**EPA Superfund
Explanation of Significant Difference
for the Record of Decision:**

**Cornhusker Army Ammunition Plant
Hall County, NE
2/7/1997**

**CORNHUSKER ARMY AMMUNITION PLANT (CHAAP)
OPERABLE UNIT ONE**

EXPLANATION OF SIGNIFICANT DIFFERENCES (ESD)
OU #1 Groundwater Treatment Plant
Change of Discharge Location
of
Treated Effluent Water

GENERAL AREA
PLOT PLAN

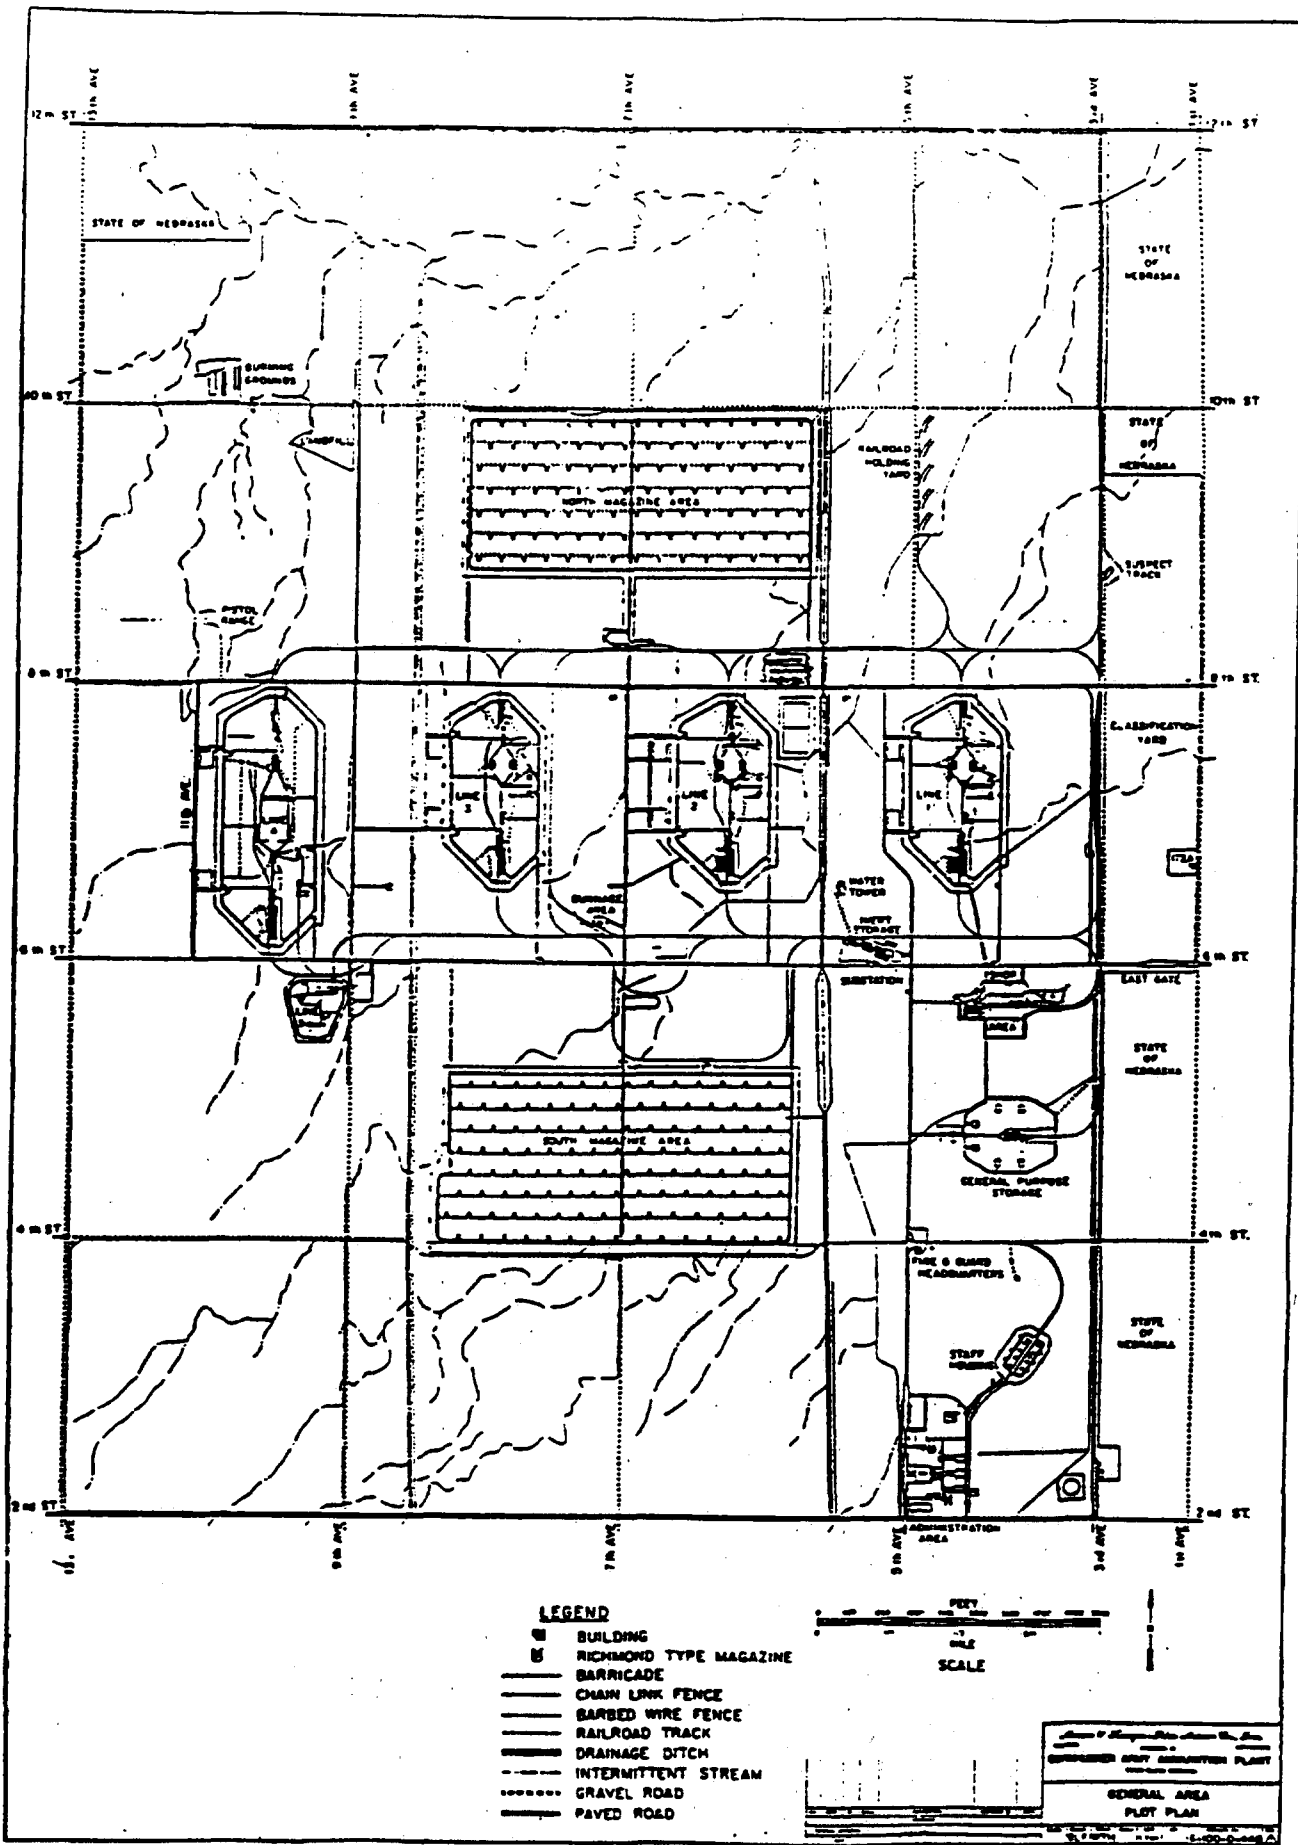
Under the phased approach, the Army proposes to begin on-site extraction and treatment as soon as possible. The treated water would be discharged to an existing

drainage canal located on CHAAP. The water in the canal would discharge to Silver Creek after traveling through CHAAP for about two miles. This proposal differs significantly from the earlier Silver Creek discharge proposal in two ways:
